Kitsap County
Department of Emergency Management
Tenant Improvement Bid # KC 2023-038

ADDENDUM #1
July 20, 2023

1 OVERALL ELECTRICAL SITE PLAN
SCALE: 1"=20'-0"

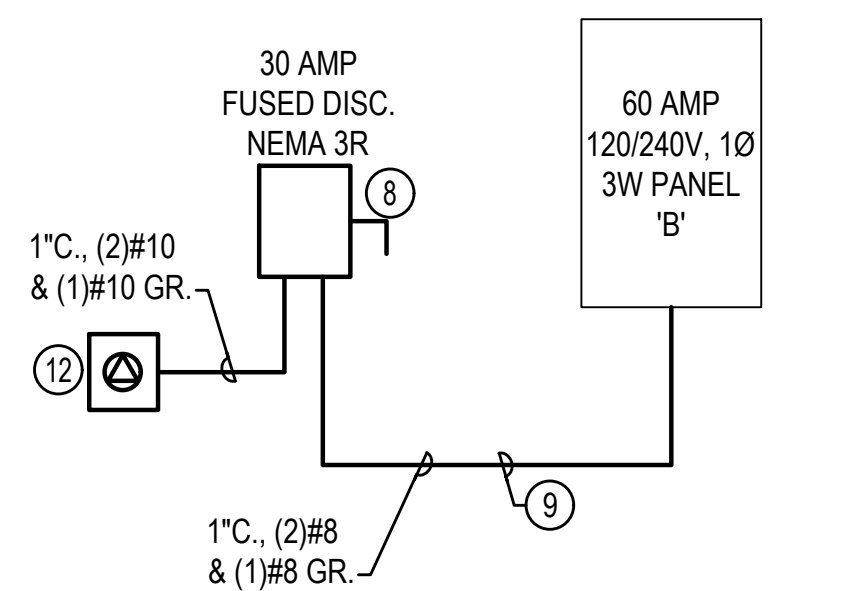
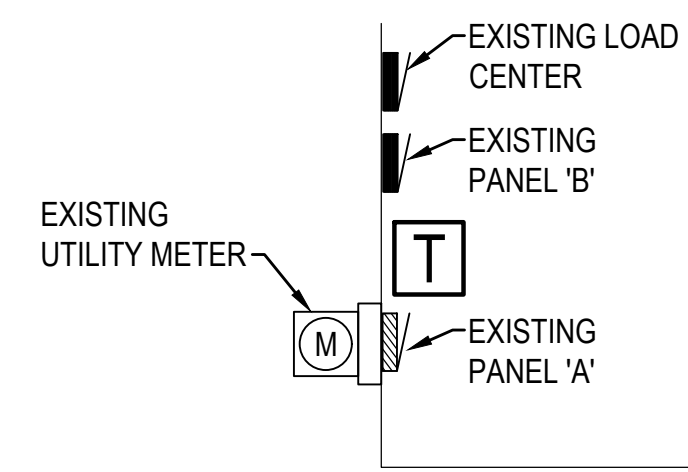
8. **REVISE** sheet E1.01 per the attached sheet E1.01.

- a. **PROVIDE** horizontal directional boring for (2) 4" conduits under the roadway to the power pole across the street for PSE primary and telecom fiber optic lines.
 - b. **REVISE** PSE primary conduit routing to the transformer per attached E1.01.
 - c. **PROVIDE** 100 amp service connection to the existing building panel behind this facility. See sheets E1.01& E5.01 attached to this addendum.
9. Sheet E0.01 Electrical Legend & Notes
- a. **ADD** Demolition Note 11 to read as follows: "Demolish existing panelboards, transformers, disconnect switches, conduit & wiring within the existing facility."
10. Sheet E5.01 Electrical One-Line Diagram
- a. **ADD** a 100 amp 120/208, 1 phase feeder to existing Warehouse panel. See revised sheet E5.01 attached to this addendum.

16. PROVIDE DIRECTIONAL HORIZONTAL BORING OF (2) 4"C. UNDER EXISTING ROADWAY FOR NEW PSE POWER & FIBER OPTIC CABLE.
17. REMOVE POLE AFTER INSTALLATION OF NEW COMM LINES.
